UNITED STATES PATENT AND TRADEMARK OFFICE

10/658,696

| Office Action Summary | Application No. 10/658,696 | Applicant(s) DUZAC, RENE | |

DETAILED ACTION

FIG. 1

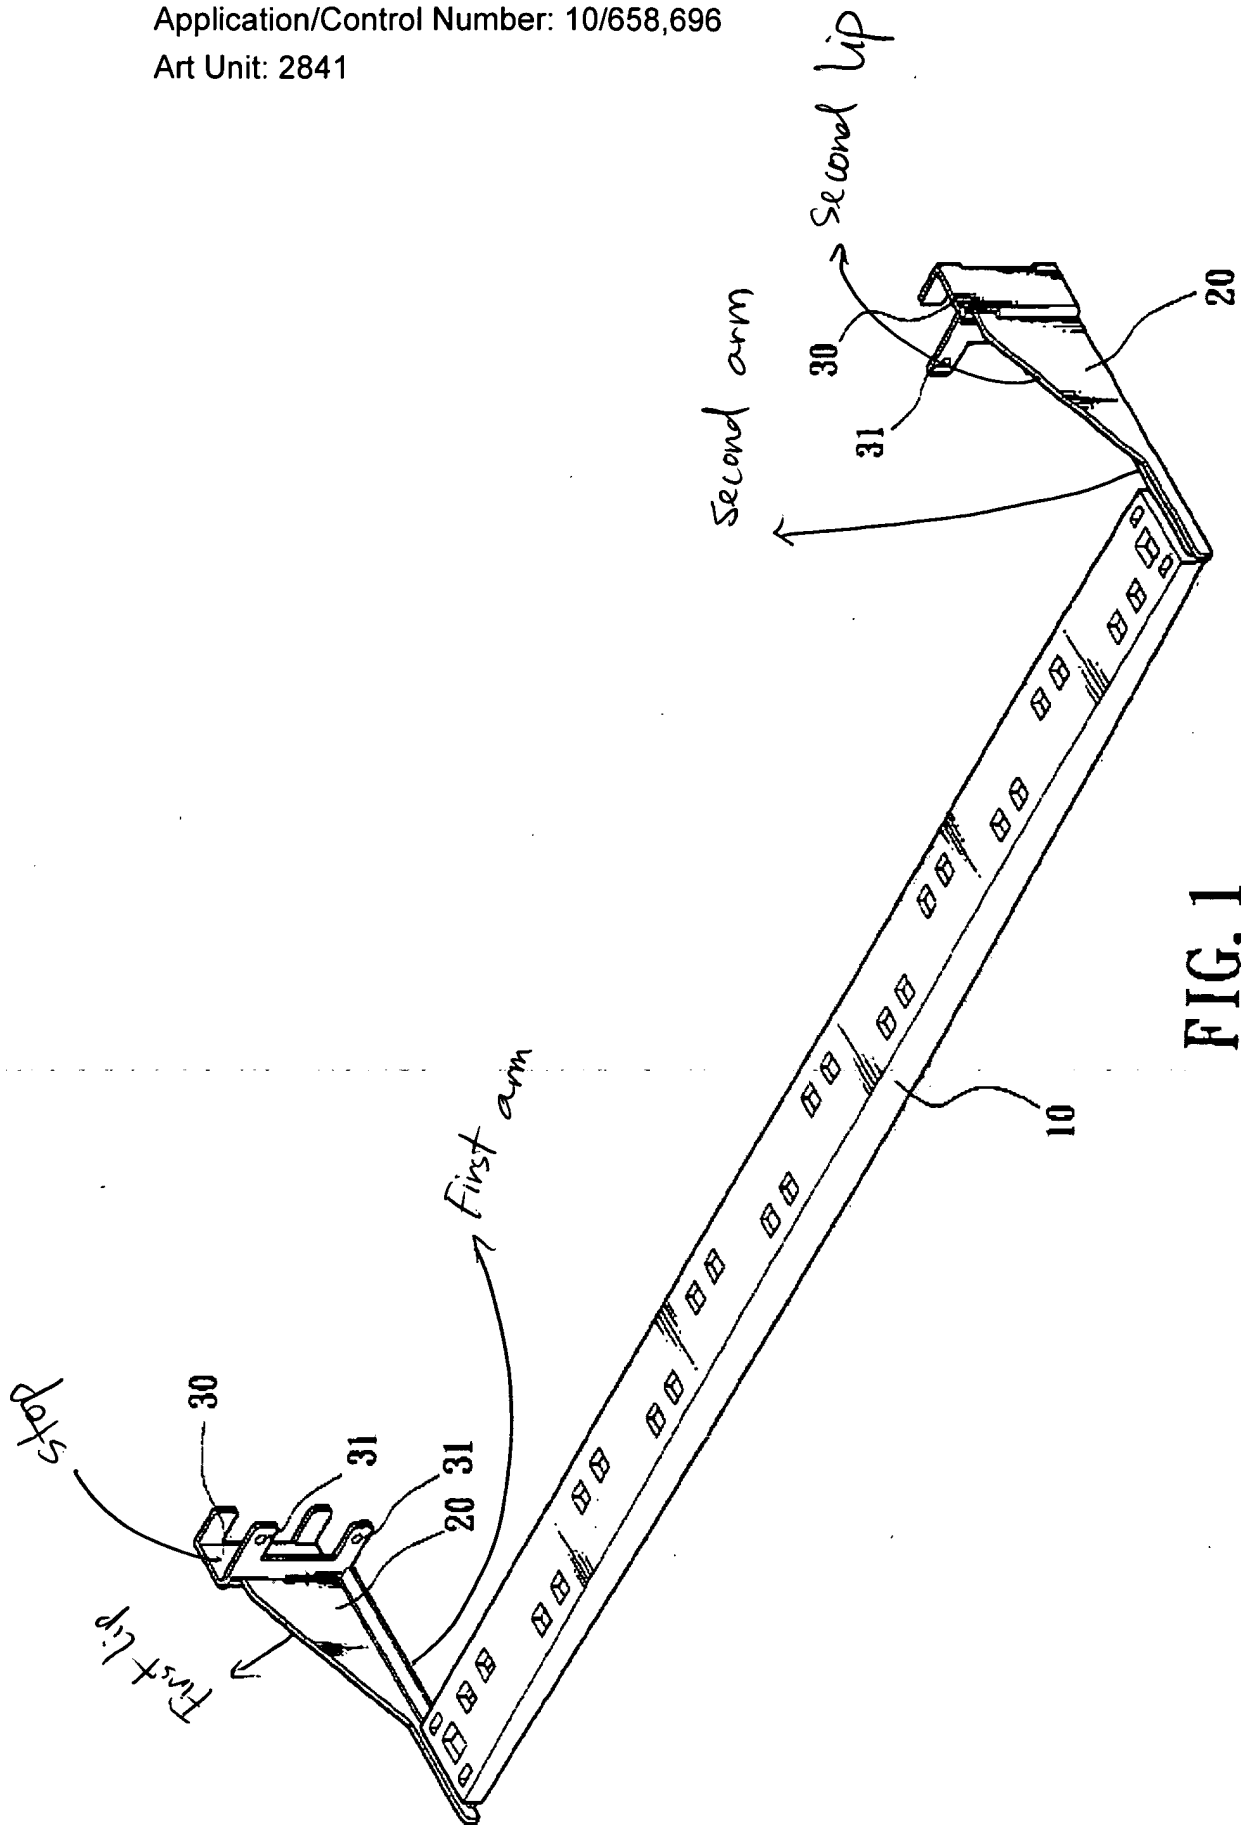
4. With respect to claims 2, 10, and 18 Chen discloses the lip of the support assembly defines a stop, the stop substantially perpendicular to the first plane defined by the support and configured to abut a faceplate in communication with the circuit board assembly, the stop configured to limit rotation of the support relative to the faceplate when the at least one cable exerts a load on the support (see examiner figure's next page).

in communication with the second arm, the second lip defining a second plane substantially perpendicular to the second arm, the first lip and the second lip configured to limit deflection of the handle relative to the circuit board assembly when the at least one cable exerts a load on the handle (see examiner's figure on page 4 above) .
